MERCON ATF IS BEING REPLACED BY MERCON V AS A SERVICE FLUID FOR SOME MANUAL TRANSMISSIONS

TSB 06-26-1

Figure 1 - Article 06-26-1

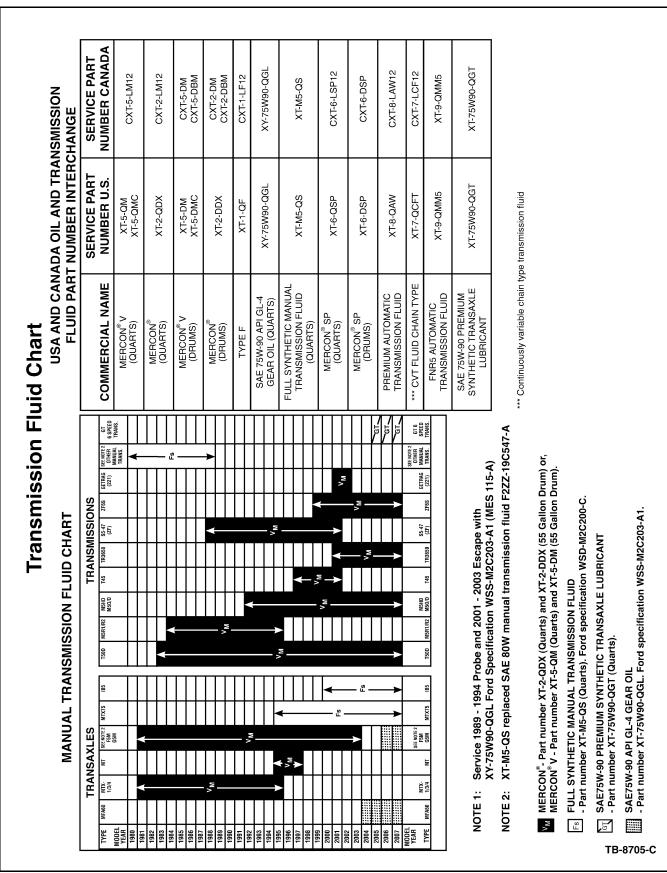
MERCON® Automatic Transmission Fluid is being replaced by MERCON® V as the service fluid for manual transmissions originally requiring MERCON®.

Service manual transmissions requiring MERCON® with MERCON® V or MERCON® Automatic Transmission Fluid or dual usage fluids labeled MERCON/MERCON® V. For proper fluid application on current and past model manual transmissions refer to the fluid usage chart. (Figure 1)

Beginning immediately all manual transmission applications requiring MERCON® can now be serviced using MERCON® V or MERCON® Automatic Transmission Fluid or dual usage fluids labeled MERCON® / MERCON® V. After July 1, 2007, MERCON® Automatic Transmission Fluid will no longer be manufactured, therefore, availability of this fluid will continue until remaining inventory has been depleted.
